Process Change Notice

All Silicon Controlled Rectifiers manufactured in the TO-92-18R epoxy package.

Figure 1. Present Package

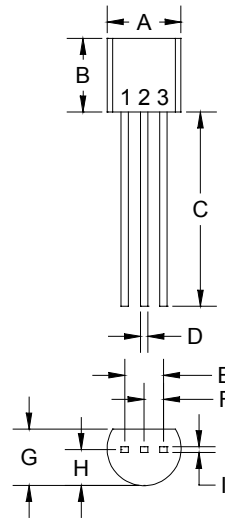
Device will no longer be manufactured with the TO-92-18R lead form and is offered as a standard TO-92 device (See Figures 1 and 2 on page 2). For customer's requiring the lead formed device, lead forming is still available from the factory at an additional cost.

Through hole designs that require the TO-92-18R lead form will not accept the standard (in-line) TO-92 leads. This change does not affect the lead code of these devices.

Add "-18R" to the part number to specify the TO-92-18R lead formed package.
